Clarification proposals for ISO B2 fixture

1. Solve interference between cushion & seatback parts
2. Facilitate the path seatbelt path in the cushion part
3. No need to define the centre of gravity for the ISO B2

1. Solve interference between cushion & seatback parts

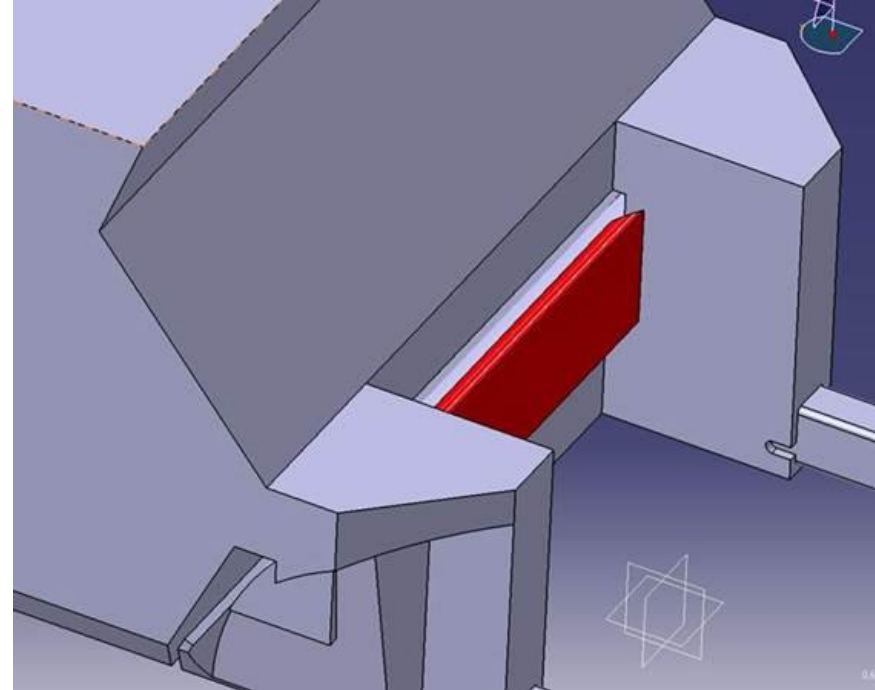
It is necessary to cut the interference part of seat back.

2. Seatbelt path in the cushion part

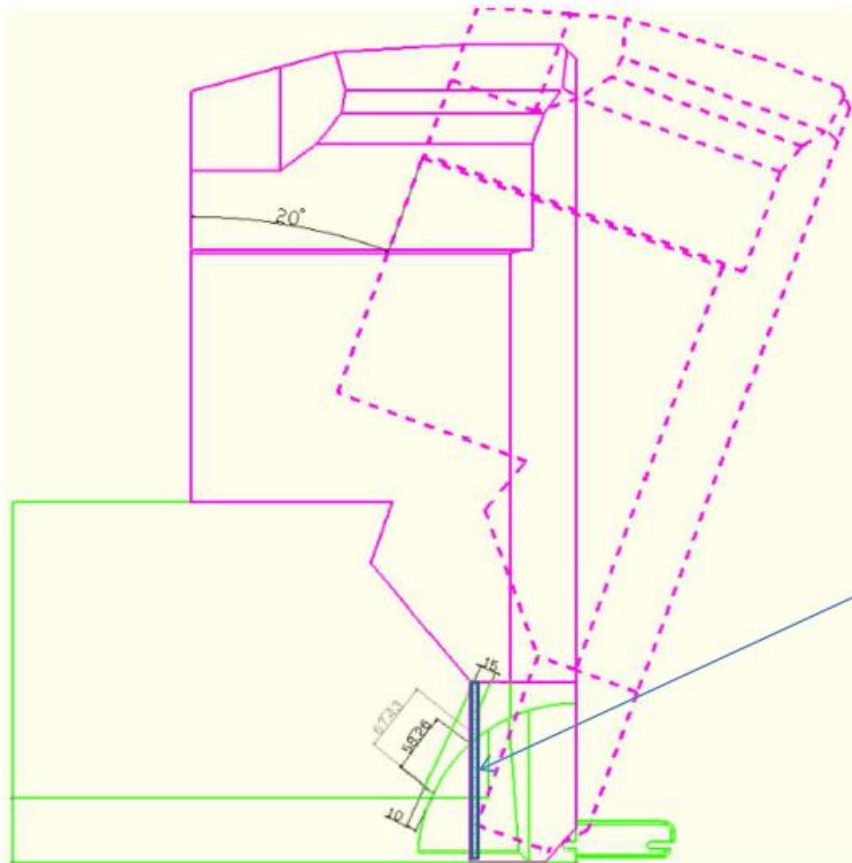
- Open the slit **on the upper zone** instead of lower
- Insure **15mm width** for the slit
- Enlarge to **67,5mm the rounded** area

⇒ easier to install the seatbelt
